ENGINE - LP COMPRESSOR- DELETION OF POLYRUETHANE COATING ON FRONT FAIRING ASSEMBLY -
CATEGORY CODE 8 - MOD.ENG-72-0136

V2500-ENG-72-0136

Installation of the Front Fairing Assembly - Before and After Alteration
Fig.1

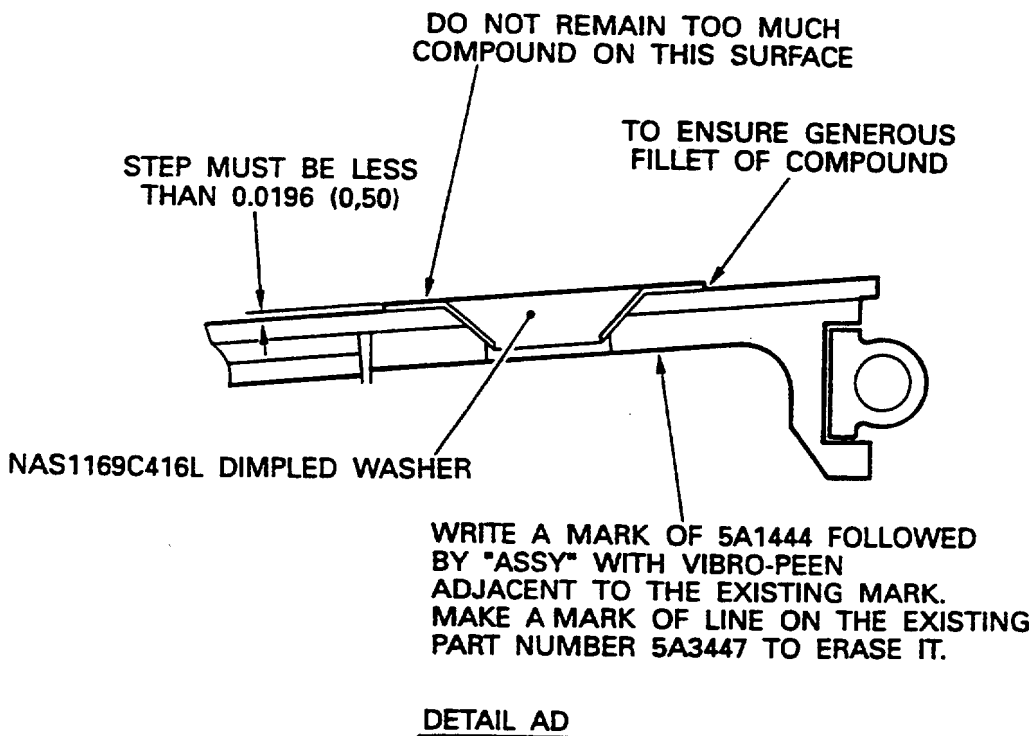
This Service Bulletin introduces a new Front Fairing Assembly which has been deleted the polyruethane coating on the outer surface.

- (1) The changes introduced by this Service Bulletin are as follows.
 - (a) The polyurethane coating on the outer surface of front fairing assembly has been deleted (See Figure 1).
 - (b) The dimpled washers which attach the front fairing assembly to the bracket are bonded on to the front fairing assembly (See Figure 1.).
- (2) Old part can be reworked and reidentified to the new configuration which is applicable to the service use only by incorporation of bonding of the dimpled washers on to the front fairing assembly (Refer to Figure 2.).
- (3) New front fairing assembly will be available for future replacement purposes.

Rework of Front Fairing Assembly
Fig.2

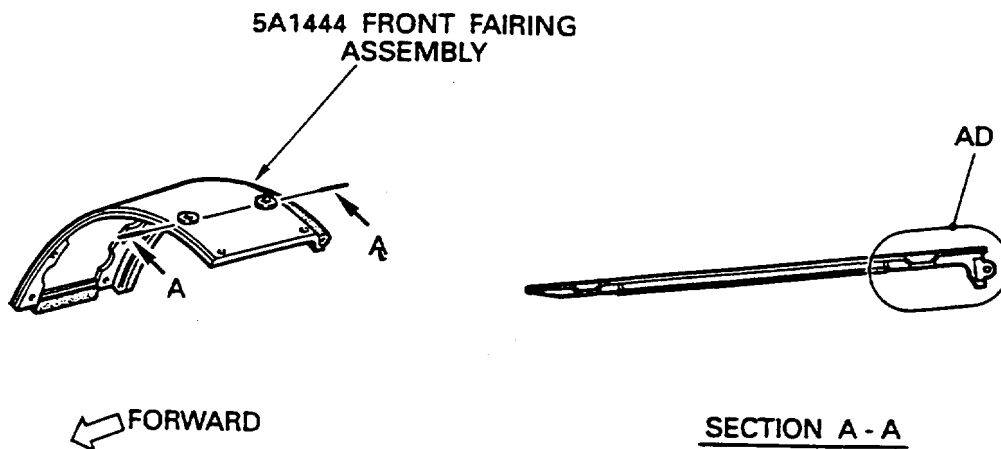
Procedure	Supplementary Information
(1) Cold liquid degrease each mating surface of the 10 NAS1169C416L, Dimpled Washers and the dimpled holes on each 5A3447, Front Fairing Assembly.	Refer to Figure 2 and 1.K (3), TASK 70-11-14-100-501.

(2) Hand clean each mating surface of the 10 NAS1169C416L, Dimpled Washers and the dimpled holes on each 5A3447, Front Fairing Assembly with CoMat 05-017 Garnet paper or CoMat 05-016, Garnet paper.	Refer to Figure 2 and 1.K (4).

(3) Do step (1) again.	
(4) Apply a thin layer of CoMat 08-014, Primer for Silcoset 151, 152, 153 to each mating surface of the 10 Dimpled Washers and the dimpled holes on each Front Fairing Assembly then dry in air for 30 minutes.	Refer to Figure 2 and 1.K (4).

(5) Apply the CoMat 08-013, Cold Curing Silicone Compound (Silcoset 152), to each mating surface of the Dimpled Washers and the dimple holes on each Front Fairing Assembly. Use a corrugated scraper, or other tool, to apply the compound to the mating surfaces at the necessary thickness.	Refer to Figure 2 and 1.K (4).

(6) Assemble the 10 Dimpled Washers on to the dimpled holes on each Front Fairing Assembly immediately or not longer than three minutes after the compound is applied.	Refer to Figure 2.

| (9) | Examine the reworked area and the steps between the Dimpled Washer and the Front Fairing Assembly. | Refer to Figure 2. |
| (10) | Renumber the identification number of the Front Fairing Assembly with the Vibro-Peening method. | Refer to Figure 2 and 1.K (3), TASK 70-09-00-400-501. |
